**RESOLUTION SETTING HEARING ON REQUEST FROM SUNDANCE, INC.
REGARDING THE FIRST AMENDMENT TO THE STONEY POINTE PUD
CONCEPTUAL PLAN (5959 SOUTHEAST 14TH STREET)**

(ZON2017-00157)

STAFF REPORT TO THE PLANNING COMMISSION

DOUBLE SIDED MONUMENT SIGN
NO SCALE

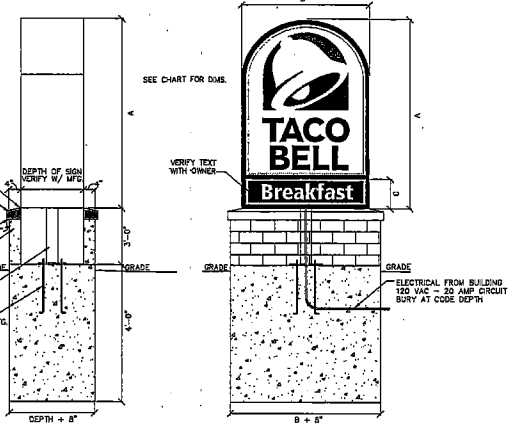
1. **Purpose of Request:** The appellant has installed a freestanding internally illuminated sign to identify the occupant of the premises, Taco Bell. The sign was installed on a previously existing pre-cast concrete masonry pattern base that has a height of 15-inches (1.25 feet). The overall height of the sign is 11-feet, 9-inches (11.75 feet). The sign is located within 10 feet of the front property line along Southeast 14th Street. It was installed without issuance of a sign permit by the Permit and Development Center.

Staff believes that this is the primary applicable criterion for the appeal in question. The "FSO" Freestanding Overlay District provisions are intended to implement the PlanDSM to establish harmonious character and compatible materials.

The applicant has installed a new sign on the previously existing base, which was in character with the previous restaurant building. Staff believes that the materials are considered compatible with the new restaurant building as well. However, the base is not substantial in appearance due to the overall height of the sign.

Additionally, the overall sign height is out of scale given the proximity to the public street along Southeast 14th Street. The intention of the code is for signs within the front yard setback to have a lower profile.

Mike Simonson asked how tall is this sign.

Jason Van Essen stated 11.75 feet.

JoAnne Corigliano stated bringing the sign down to our standards would not hurt a thing.

JoAnne Corigliano stated the sign needs to be a proper size.

Staff recommends denial of the requested amendment to the Stoney Pointe PUD Conceptual Plan.

Mike Simonson moved staff recommendation for denial of the requested amendment to the Stoney Pointe PUD Conceptual Plan.
